Addendum # 1

Bid Opportunity: 24-7556-RFT – Waterloo-Oxford District Secondary School Family Studies Renovation & HVAC Upgrades

.1 REFER TO THE ATTACHED MECHANICAL & ELECTRICAL ADDENDUM #1 PREPARED BY MNE ENGINEERING LTD. DATED 12 APRIL 2024 (9 PAGES).

To:	Cornerstone Architecture	Date:	April 12, 2024
		Project:	Waterloo-Oxford District Secondary School Family Studies Renovations & HVAC Upgrades
cc:	WRDSB	Project No:	24008

2
 ASK-001
ENLARGED FLOOR PLAN

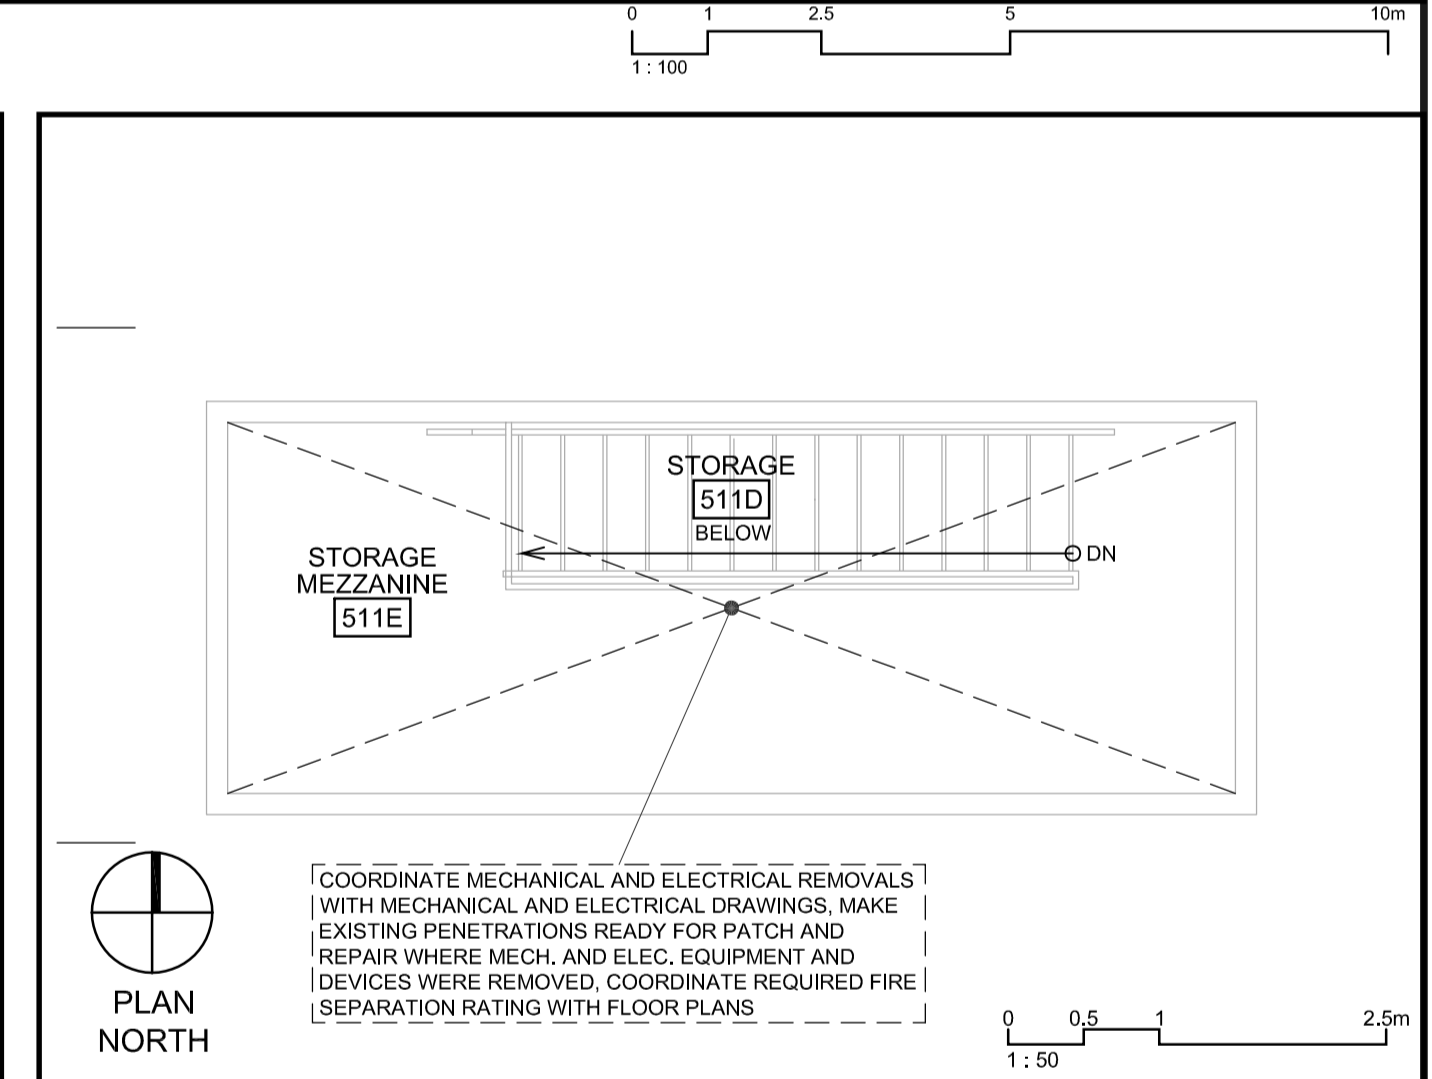
.2 **REFER TO DRAWING ASK-001, ATTACHED, FOR DEMOLITION OF EXTERIOR GAS STORAGE AREA.**

REMOVE EXISTING GAS STORAGE ENCLOSURE IN ITS ENTIRETY INCLUDING: ALL ROOFING MATERIAL, CONC. BLOCK WALLS, CHAIN LINK FENCING, GATES, AND POSTS. REMOVE FLASHING AND CLEAN OFF ADHESIVES AT EXISTING EXTERIOR WALLS
